RESPONSES TO COMMENTS ON THE DRAFT ENVIRONMENTAL IMPACT REPORT Volume 3

# Potrero Power Station Mixed-Use Development Project

SAN FRANCISCO PLANNING DEPARTMENT CASE NO. 2017-011878ENV STATE CLEARINGHOUSE NO. 2017112005

Figure 4.E-4 (Revised) Existing On-Street Parking Regulations

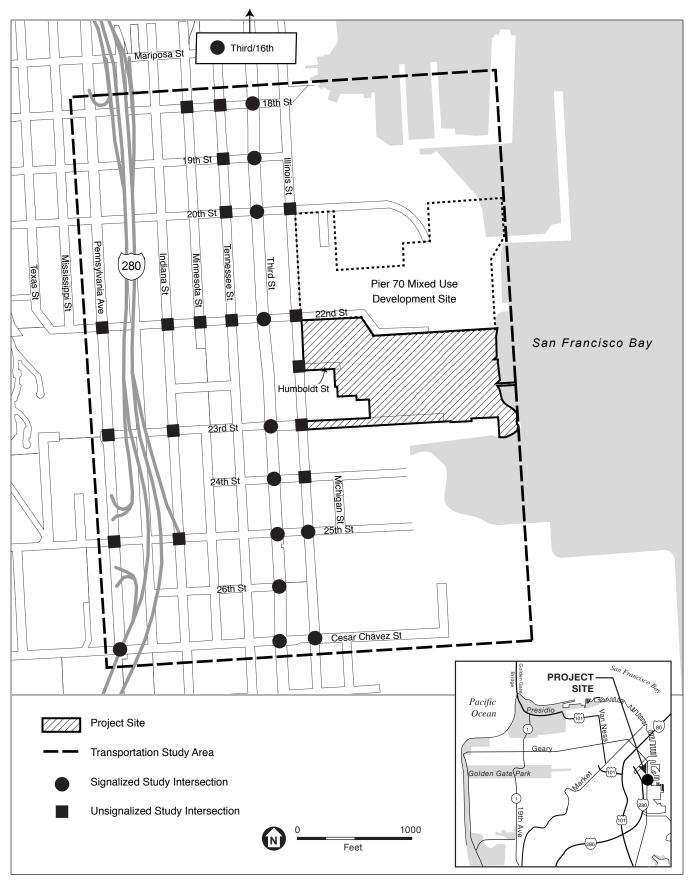
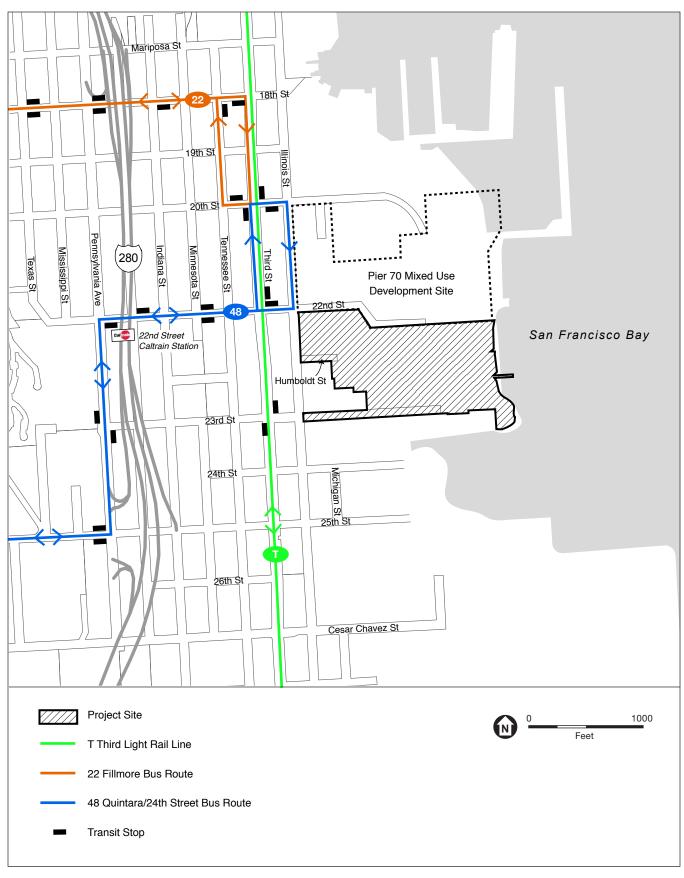
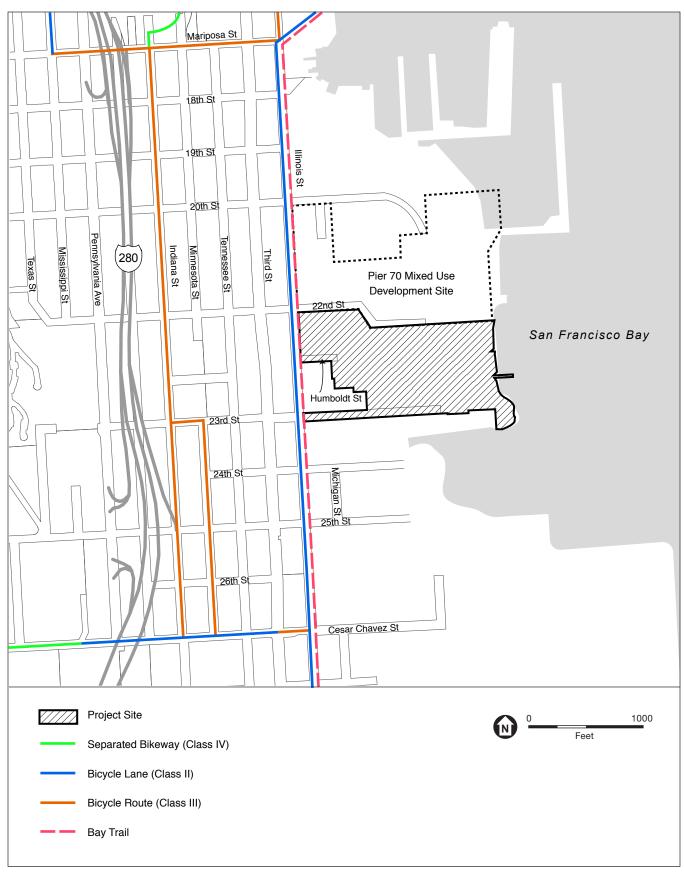
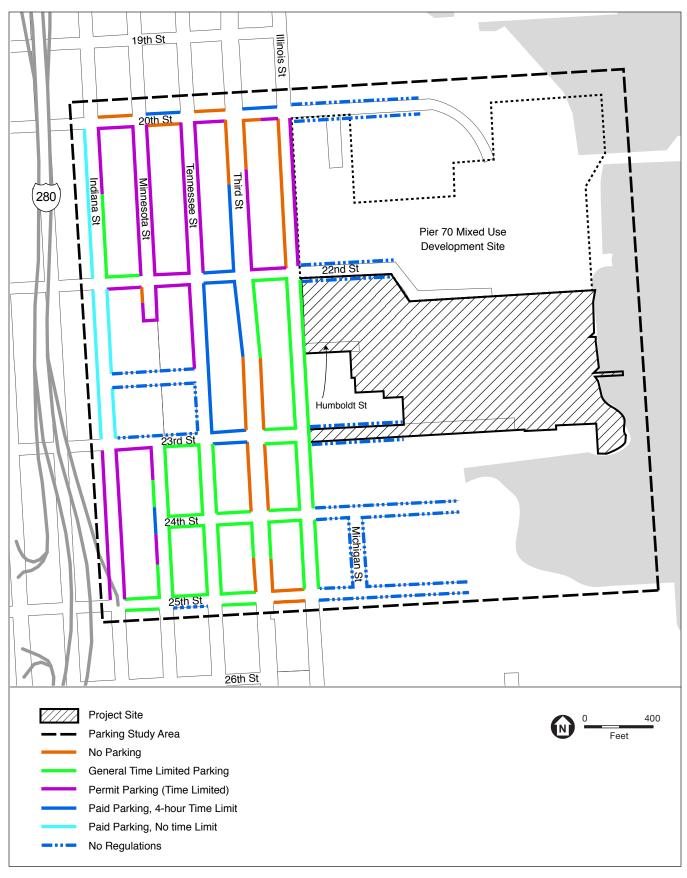
"The project site map in Figure 4.E-1 on page 4.E-2 incorrectly shows the project site as being near I-80. The freeway shown in this Figure should be labeled I-280. The same error is found in the figures following Figure 4.E-1." (*Patricia Maurice, California Department of Transportation, letter attachment, November 16, 2018 [A-Caltrans1-3]*)

In response to the comment that Figure 4.E-1 through Figure 4.E-4 incorrectly label I-80 as I-280, these figures have been corrected, and the revised figures are included in Chapter 12, Draft EIR Revisions. These revisions do not change the analysis or conclusions presented in the EIR.

In response to a comment by the California Department of Transportation, Figure 4.E-1 through Figure 4.E-4 (EIR pp. 4.E-2, -7, -6, and -20) labels for I-80 are corrected to read as I-280, this is corrected in the revised four figures shown on the following pages:
